CURRENT PLANNING STAFF ANALYSIS

CASE: Tudor Elmore Development Subdivision, Tracts 1A, 1-B, 1-C, 1-D

REQUEST: Subdivision of two (3) tracts into four (4) tracts.

Case No. S12393
Municipal Tudor Road Complex Subdivision
ENSTAR Comments
1/3/2018

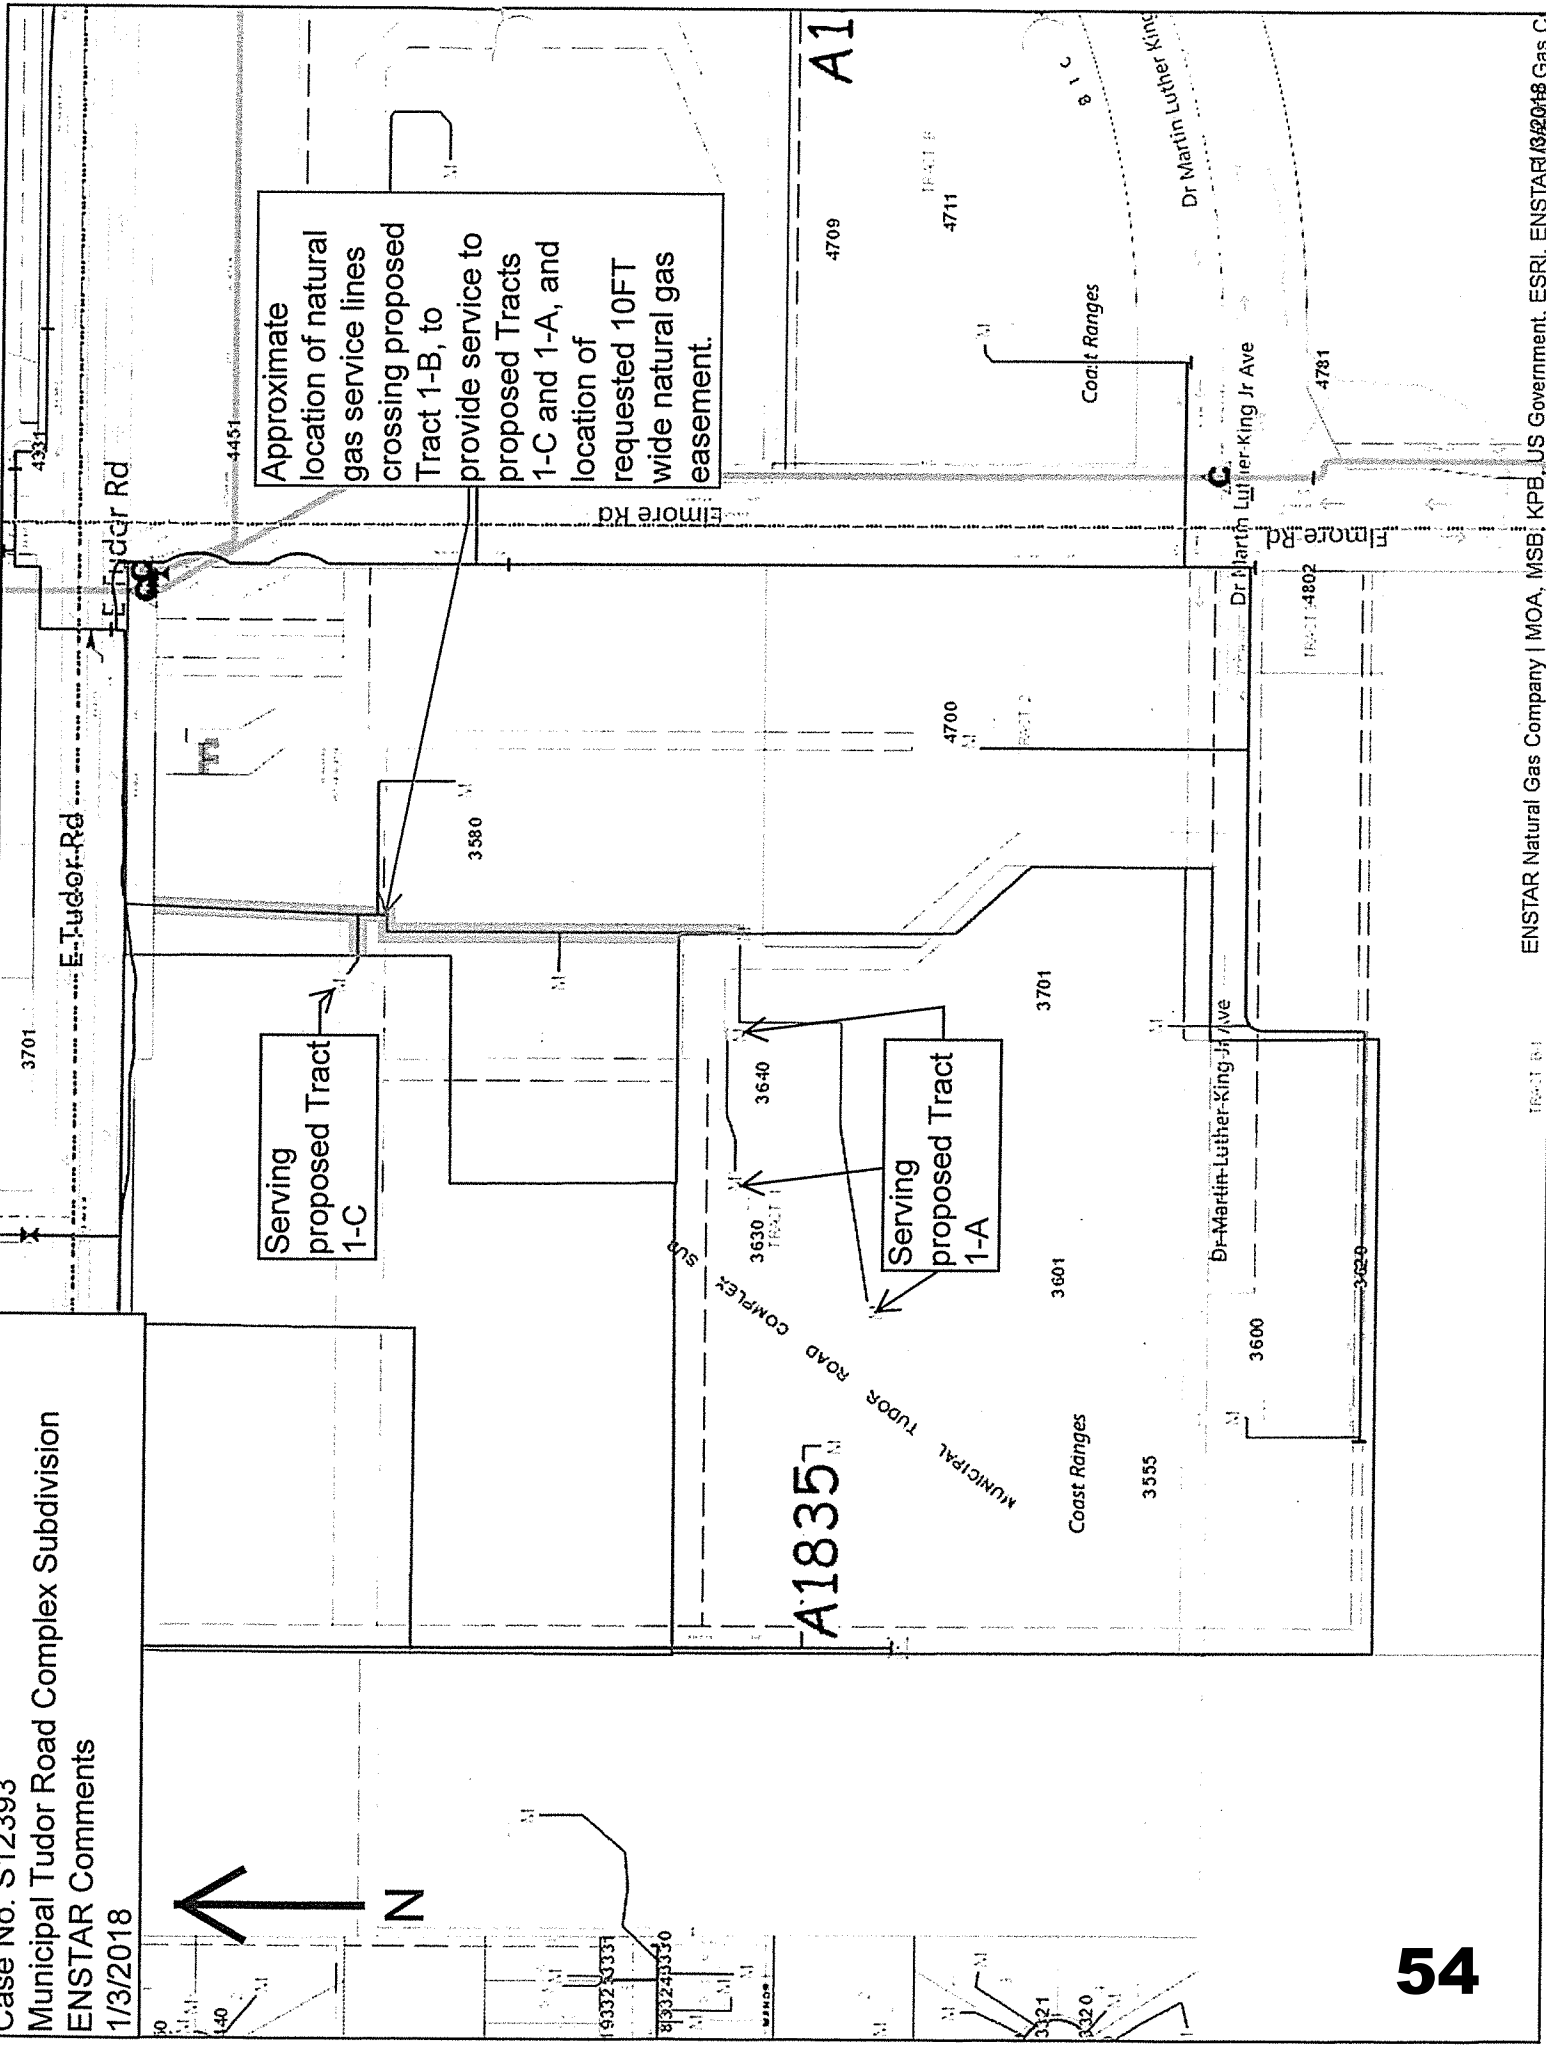
ENSTAR Natural Gas Company has reviewed the preliminary plat for **Municipal Tudor Road Complex Subdivision, Tracts 1A, 1B, 1C, & 1D (Case No. S12393)**, and advises that are existing natural gas service lines which cross proposed Tract 1-B, in order to serve proposed Tracts 1-A and 1-C. ENSTAR requires a ten foot (10 FT) wide natural gas easement, centered on the service lines as they cross through proposed Tract 1-B, to provide service to proposed Tracts 1-A and 1-C, as shown on the attached ENSTAR map. ENSTAR could accept this easement as, either an addition to the proposed plat, or a separately recorded document.

Approximate location of natural gas service lines crossing proposed Tract 1-B, to provide service to proposed Tracts 1-C and 1-A, and location of requested 10FT wide natural gas easement.
